UNITED STATES PATENT AND TRADEMARK OFFICE

APPLICATION NO.	FILING DATE	FIRST NAMED INVENTOR	ATTORNEY DOCKET NO.	CONFIRMATION NO.
10/662,792	09/15/2003	Robert E. Fischell	JOH2748P0043US	9518
32116	7590	01/12/2005	EXAMINER	
WOOD, PHILLIPS, KATZ, CLARK & MORTIMER 500 W. MADISON STREET SUITE 3800 CHICAGO, IL 60661			SWEET, THOMAS	
			ART UNIT	PAPER NUMBER
			3738

Office Action Summary	Application No. 10/662,792	Applicant(s) FISCHELL ET AL.	
	Examiner Thomas J Sweet	Art Unit 3738

DETAILED ACTION

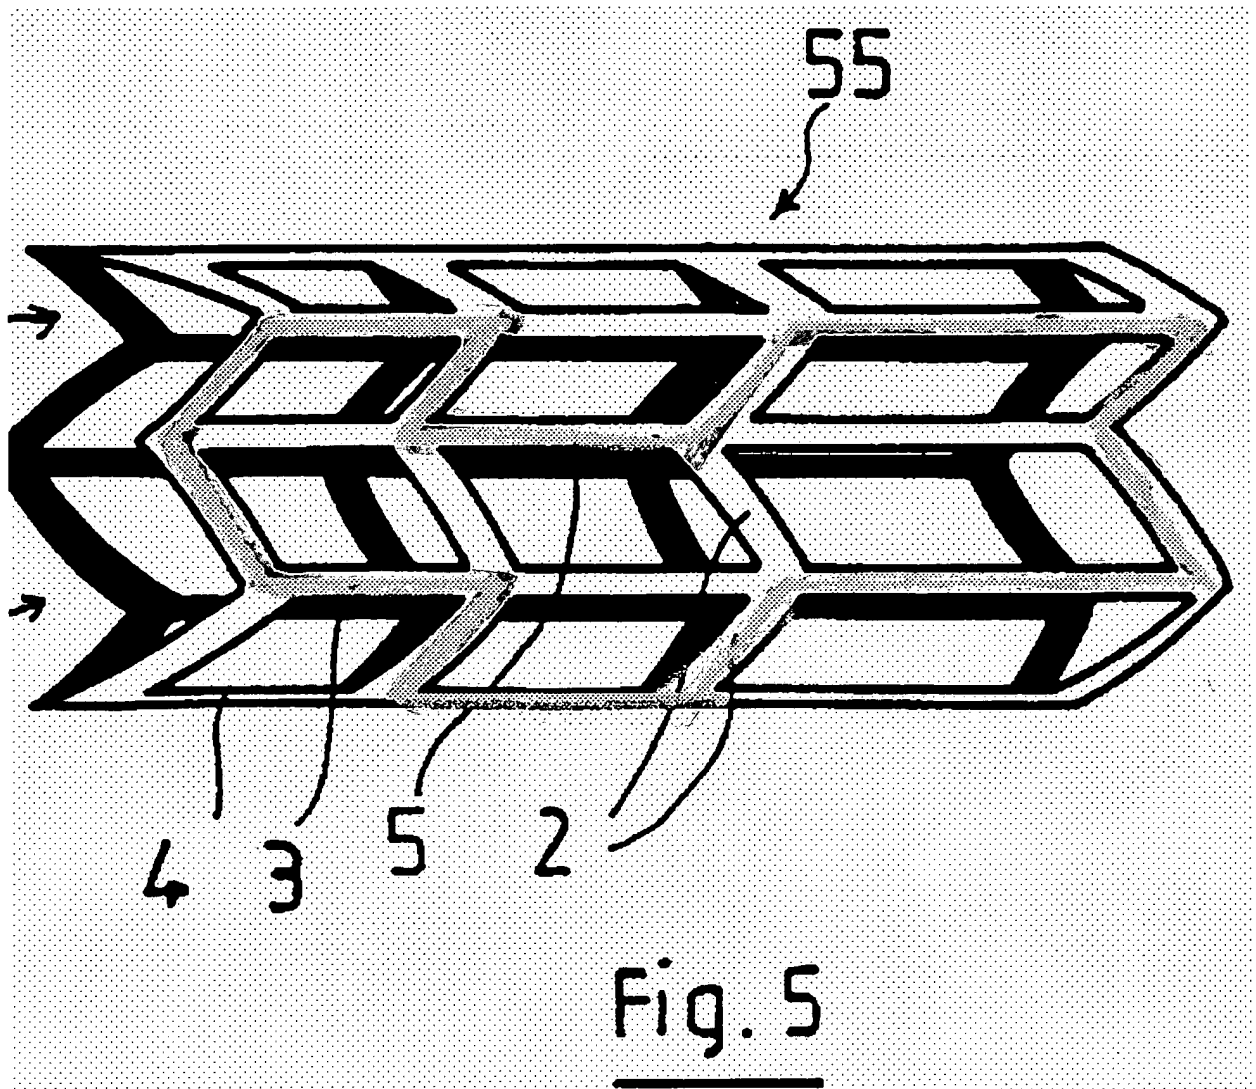
Claims 45-56 are rejected under 35 U.S.C. 102(e) as being anticipated by Sgro (US 5496365). Sgro discloses a generally cylindrical stent (e.g. fig. 5) for delivery to a coronary artery (intended use language, the stent is capable of being used in this way), said stent having a

With regard to claims 47, 48 and 50-54, cells can be bounded as shown below reading on these claims since in the broadest reasonable interpretation of the term cell does not require that it be open.

With regard to claims 55-56, cells can be bounded and include connectors as shown below reading on these claims since in the broadest reasonable interpretation of the term cell does not require that it be open.
